Response to SARA's Information Request (IR) for 'Tourist Attraction & Market at 124 Distillery Rd, Eagleby (Lot 2 SP102952) – MCUI/11/2019 – 1905-10997 SRA

Grummitt Planning Pty Ltd have been commissioned by the applicant '**Tonken Oc Pty Ltd** to respond to SARA's Information Request issued in response to the referral process under Section 12 of the Development Assessment Rules for a Material Change of Use for a Tourist Attraction & Market at the above site. The applicant has sought to provide SARA with the requested information where it has been appropriately requested and therefore provides the following response to the information requested in the respective letter dated 27th May 2019:

Response to Item 1:

SITE PLAN

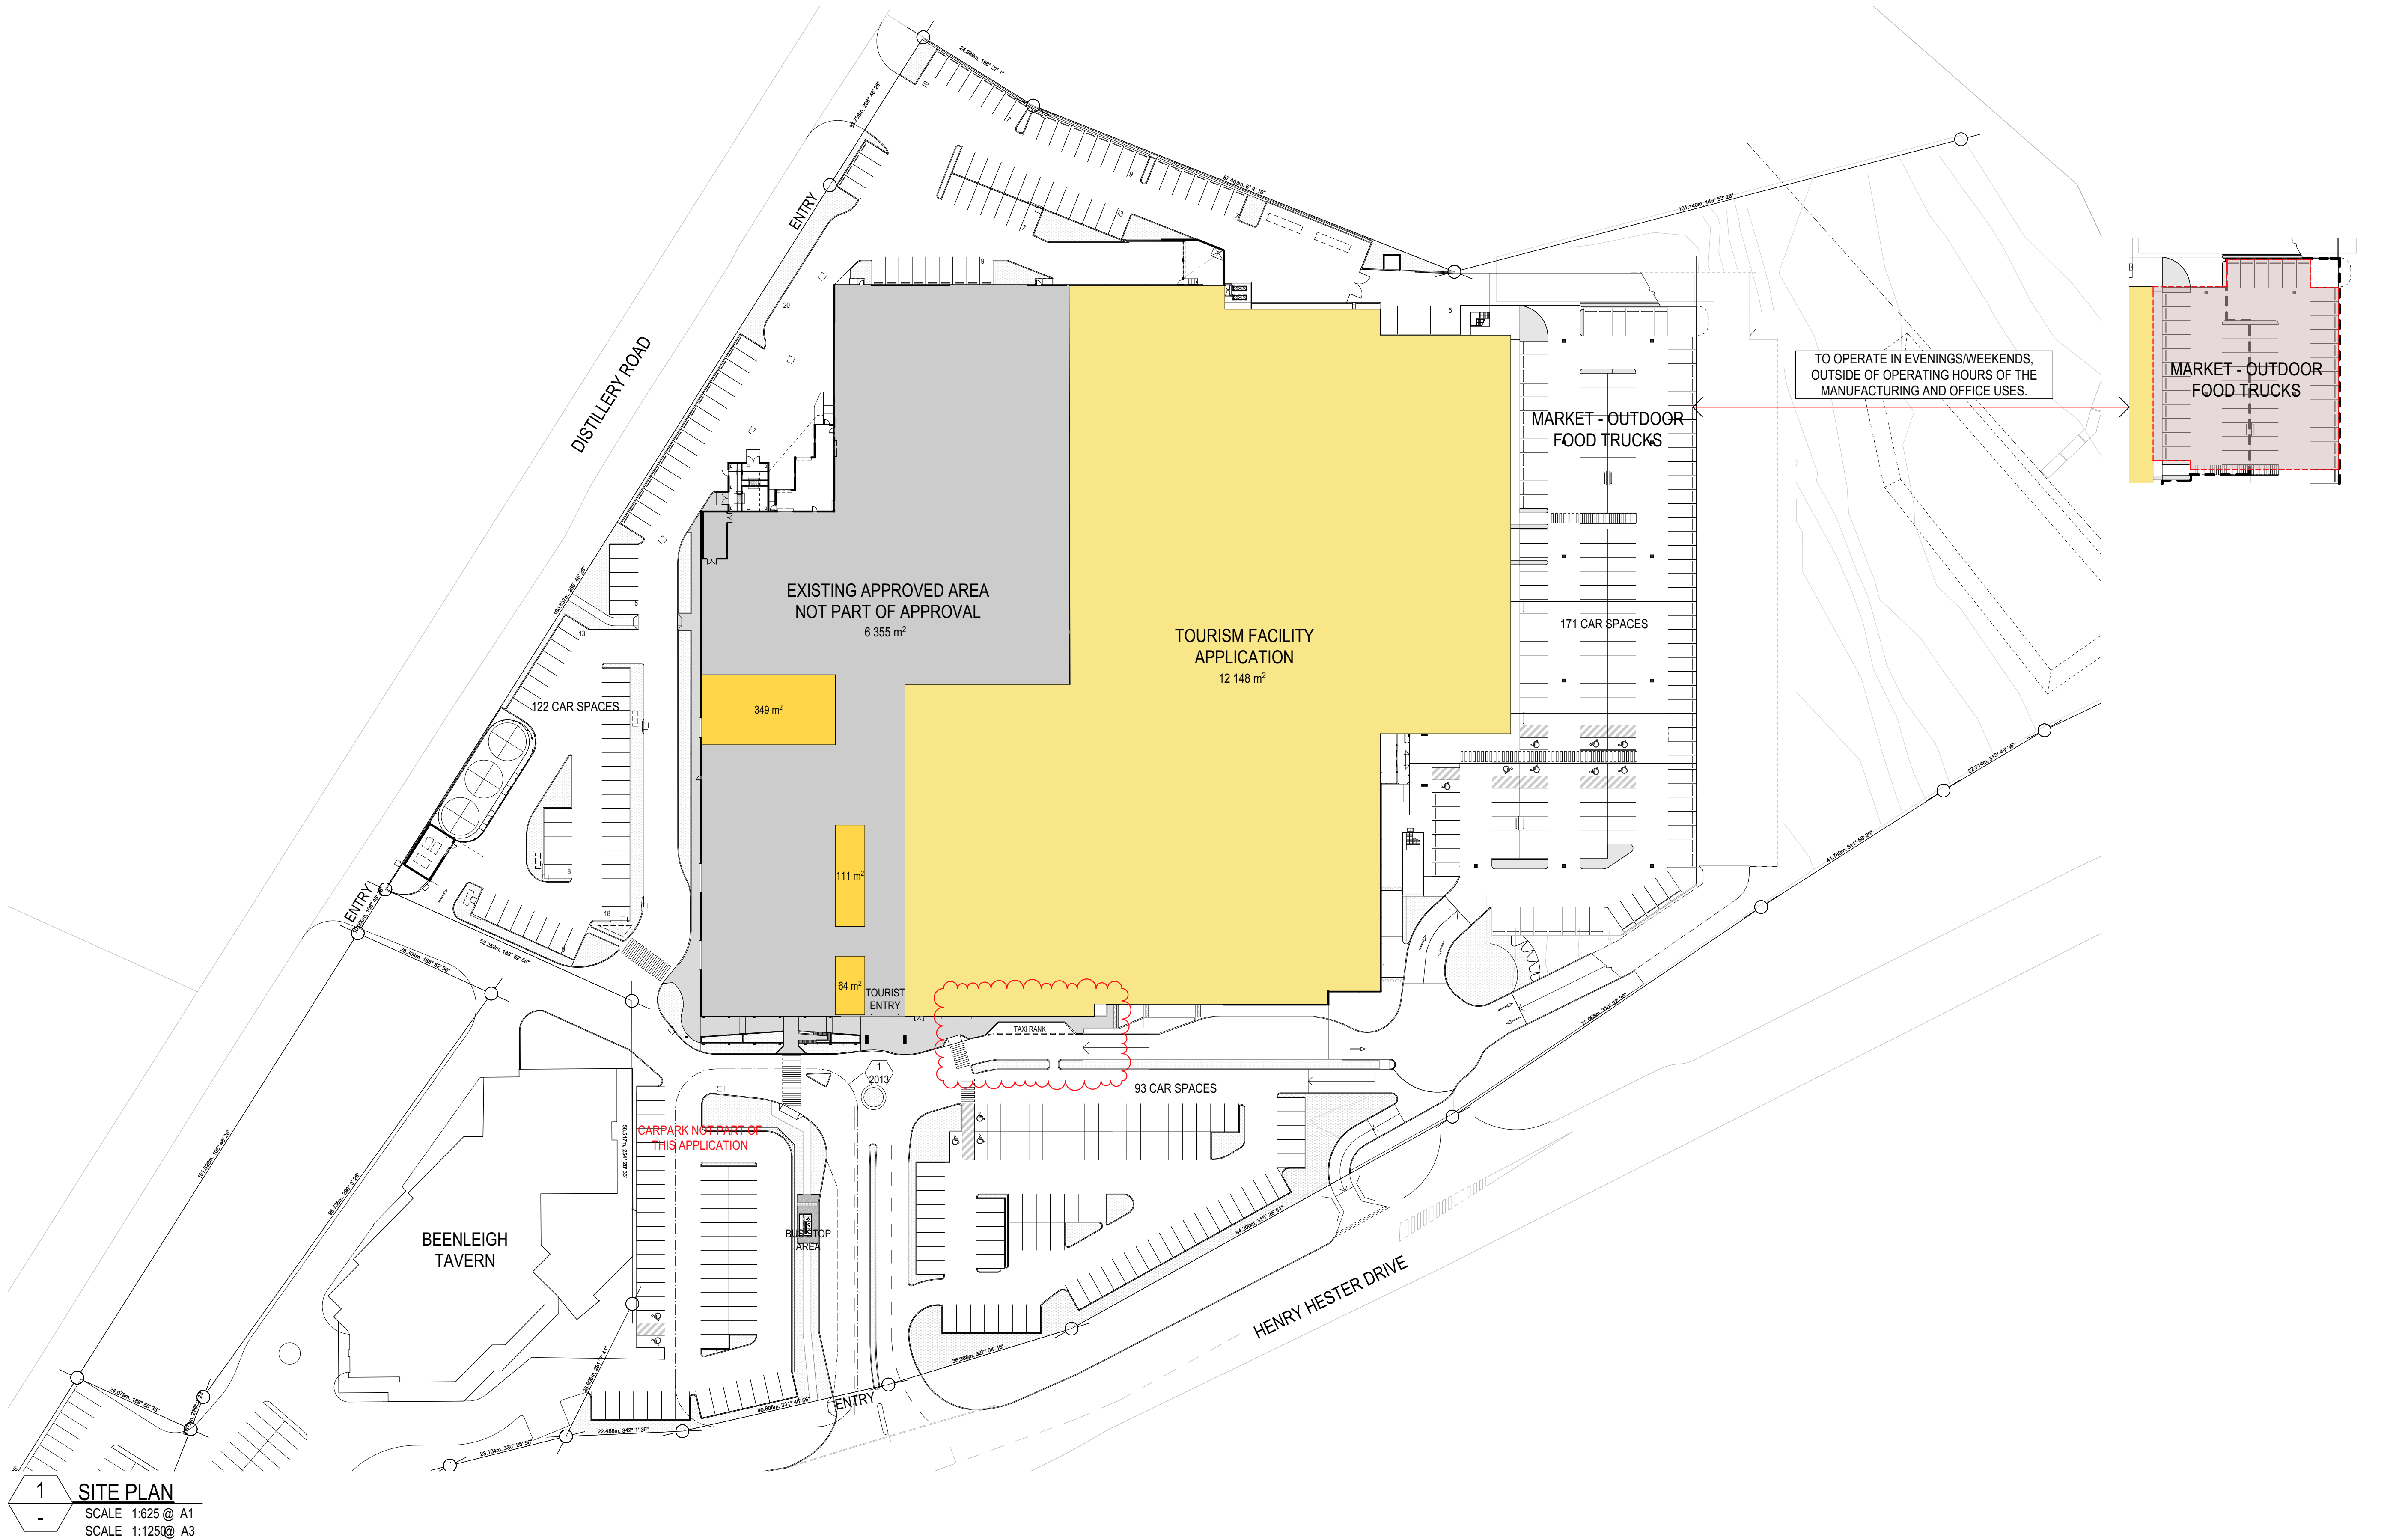
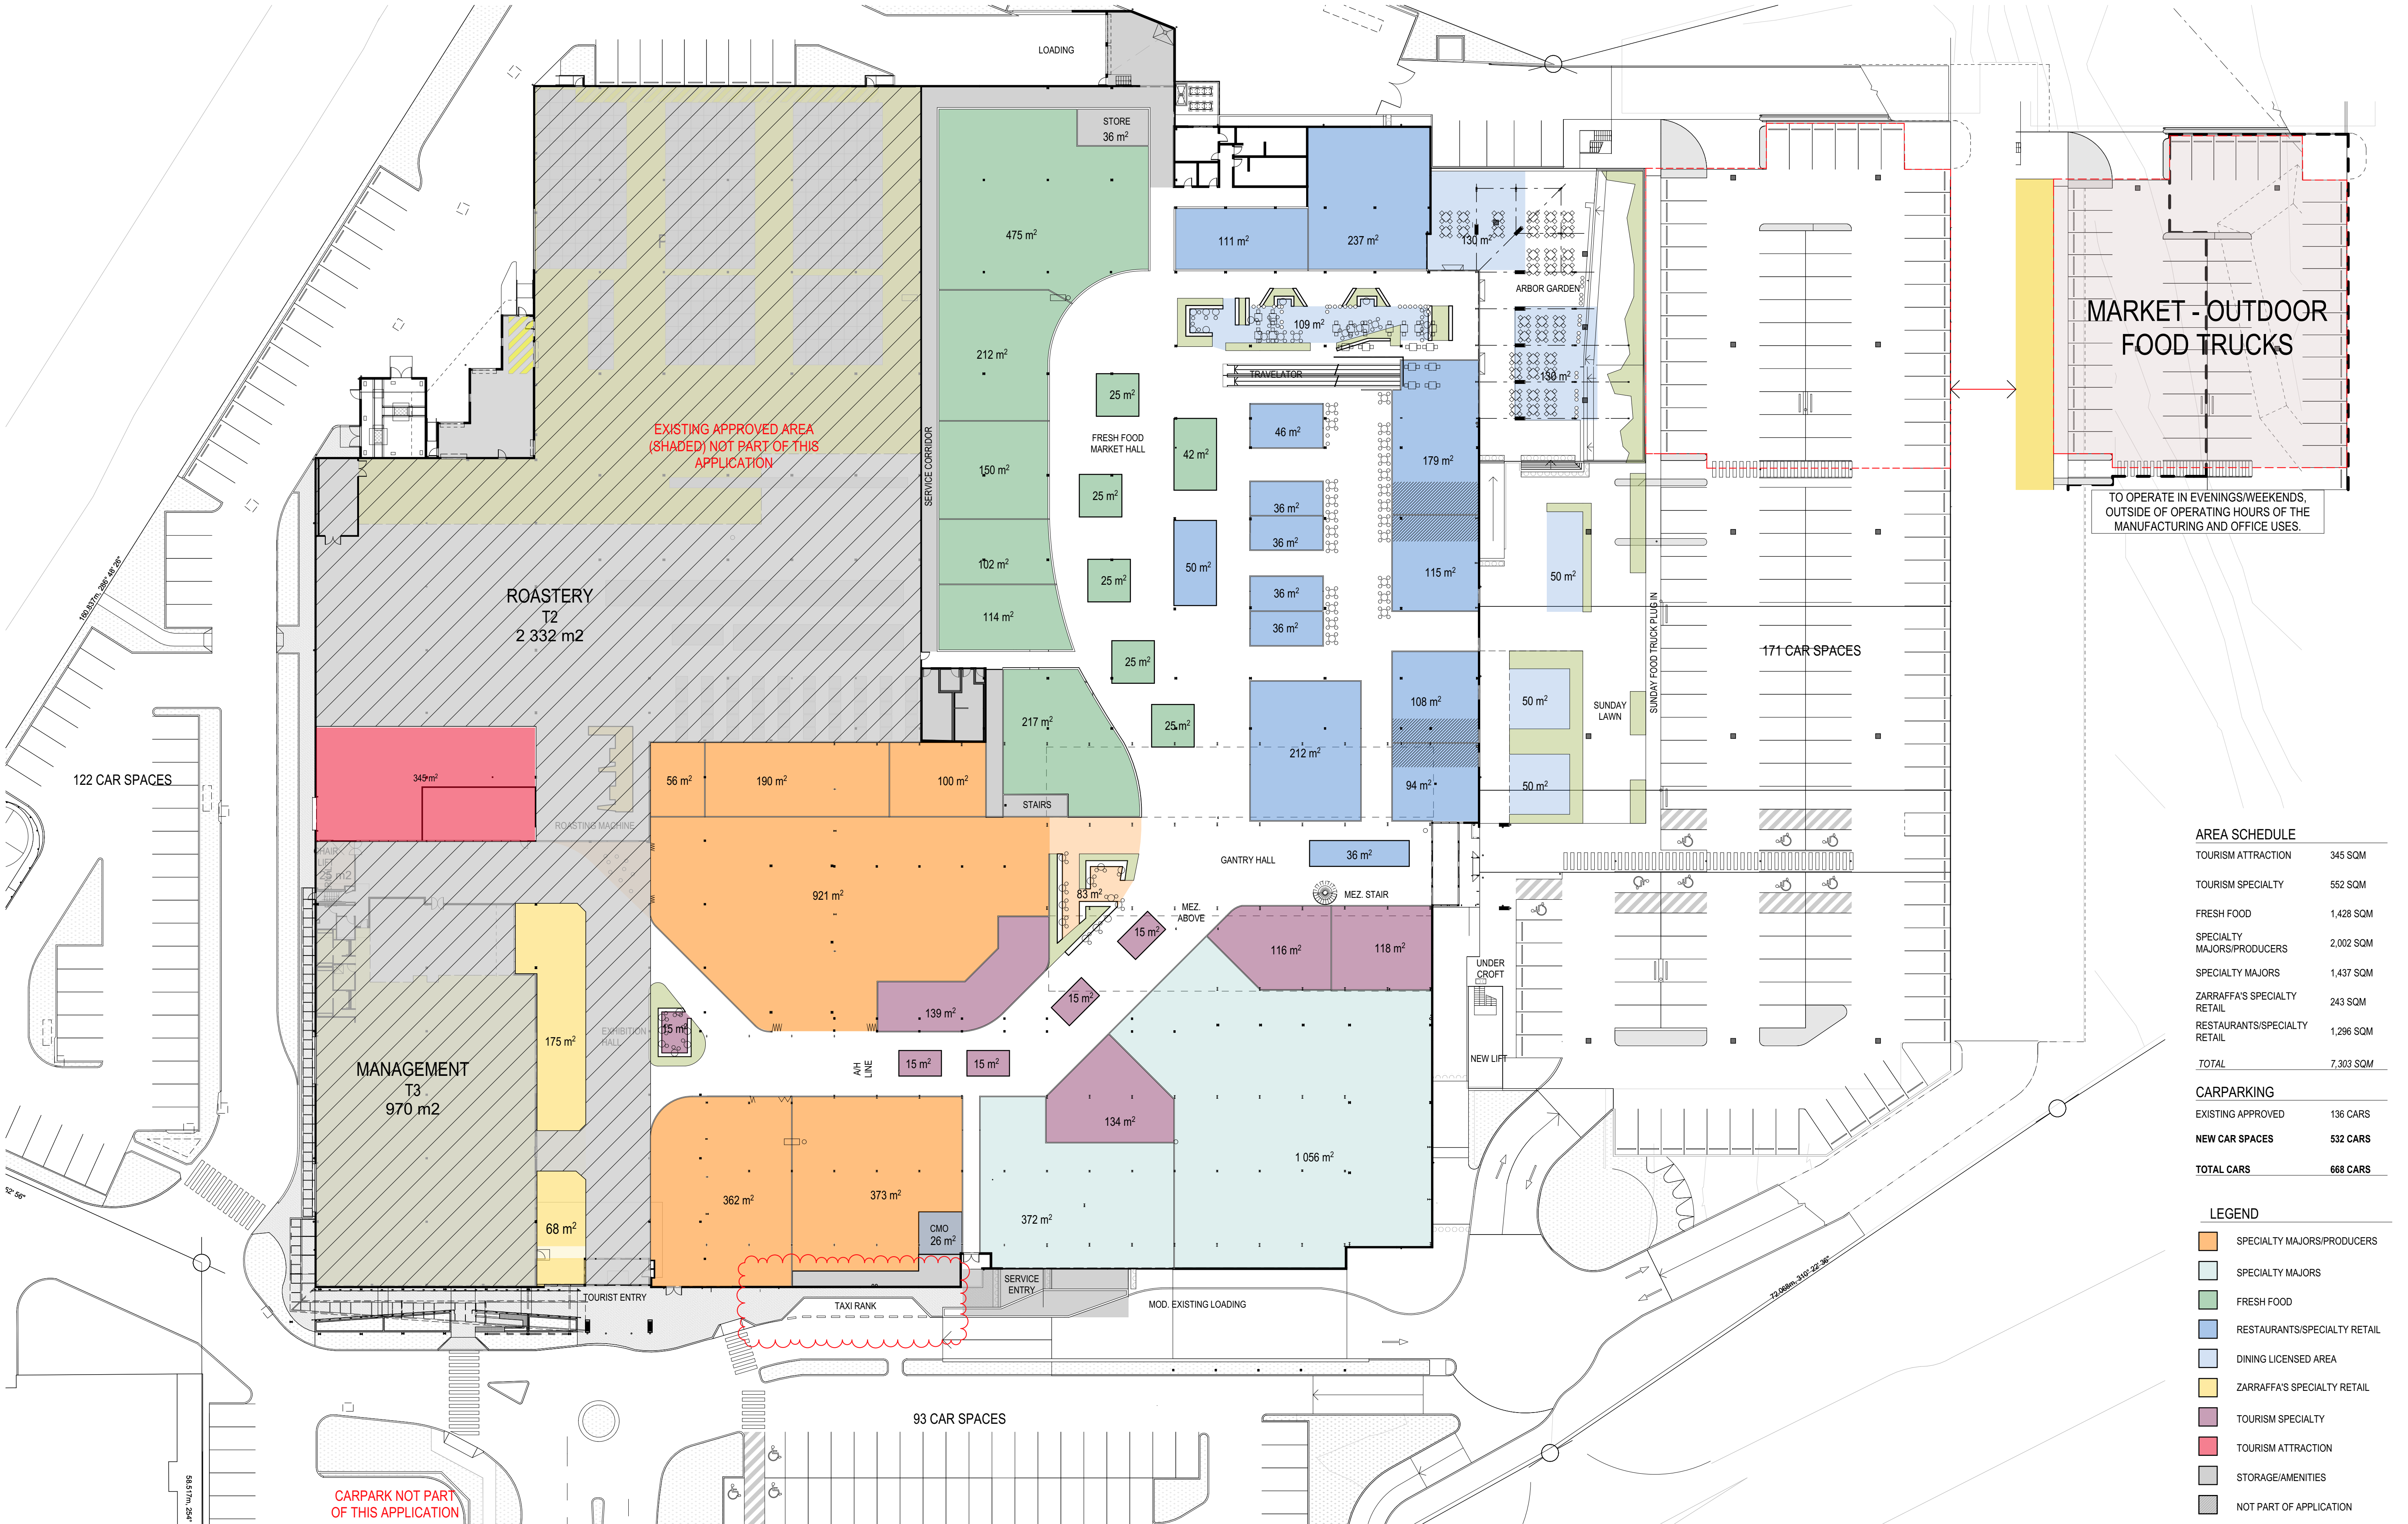
The applicant is requested to provide further information demonstrating how the proposed development achieves compliance with Performance Outcome (PO) 19, 21 and 22 of State code 6: Protection of state transport networks of the *State Development Assessment Provisions* (SDAP).

To assist in demonstrating compliance, the applicant is requested to provide:

- (a) An adequate number of taxi rank/s with sufficient capacity (number of parking bays) to cater for the demand generated by the proposed tourist attraction. This should consider likely passenger volumes and the demand for taxi services given factors such as the gross floor area of the development, use mix, anticipated demand, demographic considerations, and regular uses/activities.

- (b) Taxi ranks positioned to maximise coverage and decrease the distance that potential passengers have to walk to access the facility. Taxi ranks should be sited near uses that generate major trips, the main entry to the development and major pedestrian facilities. Taxi ranks should have their own dedicated parking bays and not be used for other pick-up and drop-off purposes.

- (c) Amended plans which demonstrate any proposed taxi ranks are located and designed to provide convenient, safe and equitable access for passengers, including people with a disability.

Given that the proposed development is a specialized tourist attraction that is not yet operational, it is somewhat difficult to depict with 100% accuracy, the precise number of persons that will attend the site on any one given day, along with their method of transport. However, given the limited public transport services within the vicinity at present, it is anticipated that the majority of attendees will arrive by their own private motor vehicle. Notwithstanding this, following advice from the traffic consultant's TTM who have been working on this project for a number of years, it was determined, two taxi bays would be adequate to cater for the demand generated by the proposed tourist attraction, given the demographics, the type of development and from professional experience with such proposals.

The taxi rank is proposed to be positioned to the frontage of the main entrance to the tourist attraction, thereby providing safe and easy access to and from the facility. In terms of equitable access, this area will be at level access and immediately adjacent to the equitable access to the main building.

Signage/road markings will ensure that the dedicated parking bays are for the parking of taxis only, and not for any other pick-up and drop-off purposes. Taxi ranks positioned to maximise coverage and decrease the distance that potential

Please see the amended drawings prepared by Cottee Parker contained in [Attachment 1](#) to this response.
